**CORRIGENDUM-2****CLARIFICATIONS TO BIDDER'S QUERIES**

Name of work: - Providing Electrical works at transit campus building of IISER Tirupati, Andhra Pradesh.
 NIT NO : 2/IISER/TIRUPATI/2017-18

DRAWING TITLE: FA & CCTV LAYOUT FOR EXISTING ADMIN BUILDING

DRAWING NO: IISER / CRN / EMEA / ELV/01

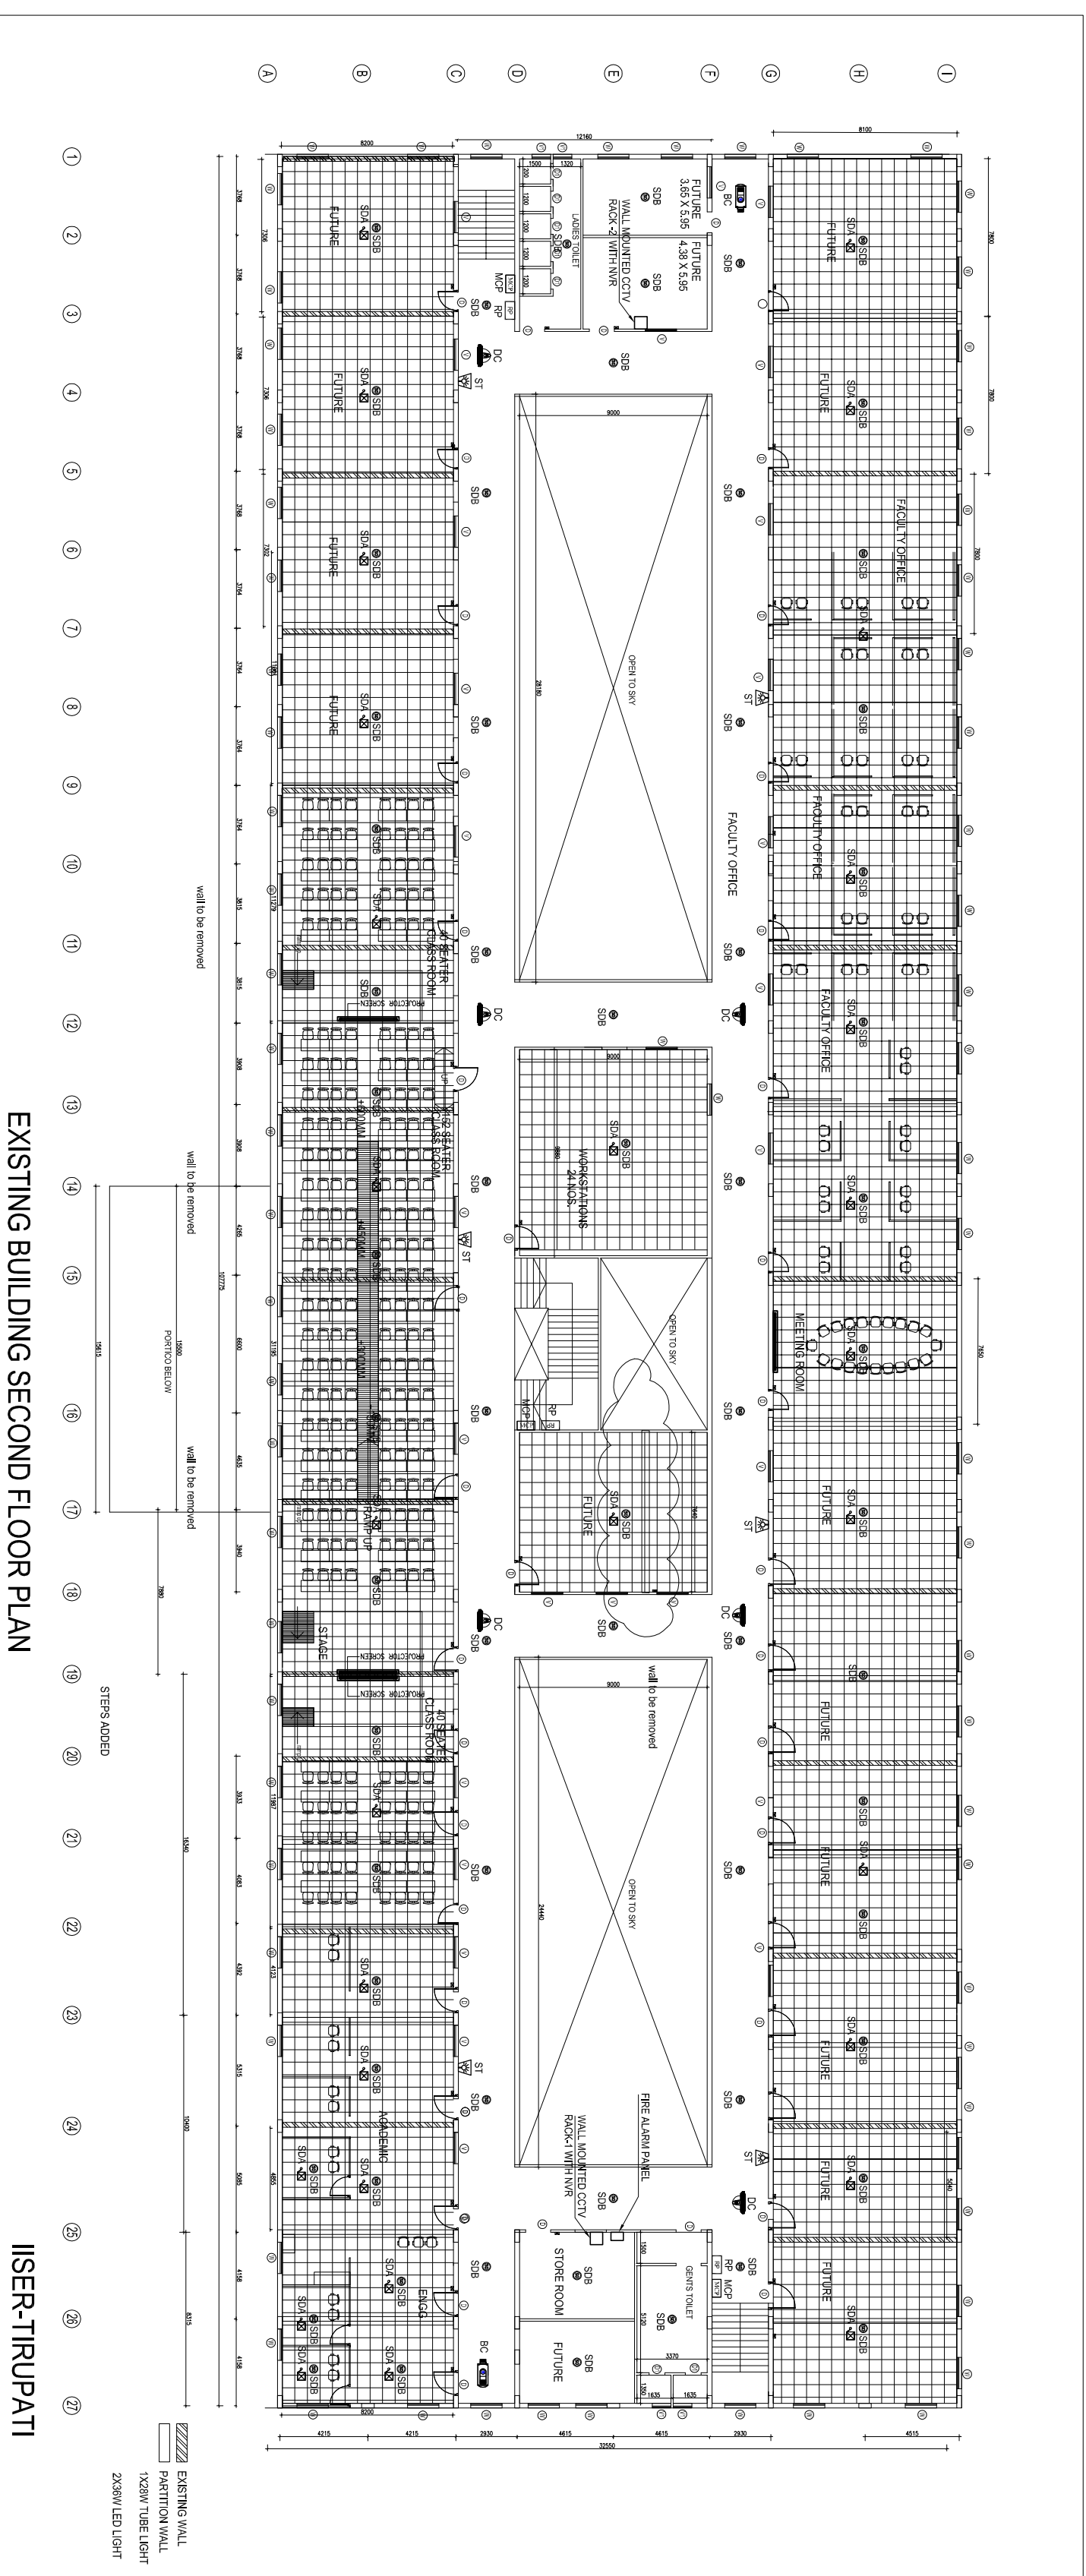
Sr No	Bidder's Query	Clarifications by IISER
1	PLEASE PROVIDE DRAWINGS IN AUTOCAD & ALSO SLD FOR LT PANELS.	Drawings required for reference of bidders are already provided along with tender document . Additional drawings in pdf format are provided for reference purpose of bidder. SLD for LT panel provided along with this corrigendum-2 for reference purpose.
2	IN POINT WIRING, WHETHER WE CONSIDER FR OR FRLS CABLE OR WIRES?	Bidder shall consider " FRLS cables/wires " for all point/Circuit wiring specified in Bill of Quantity and technical specifications. No change in quantity and unit of items.
3	SR NO. 16. 25MM PVC CASING UNIT IS EACH IN EXCEL & MTR IN PDF.	Sr.No 16 , Bill of Quantity , Unit of measurements stands modified to " meter " . Bidder shall take note it and quote accordingly. No change in quantity of item.
4	SR NO. 22.01,22.02 & 22.03 PLEASE SUGGEST CURRENT RATING FOR SWITCH & SOCKET.	Sr. No 22.01 , Sr. No 22.02 and Sr. No. 22.03 of bill of quantity current rating shall be 6A/16A Universal type socket and 16A switch. Bidder shall quote accordingly. No change in quantity and unit of item.
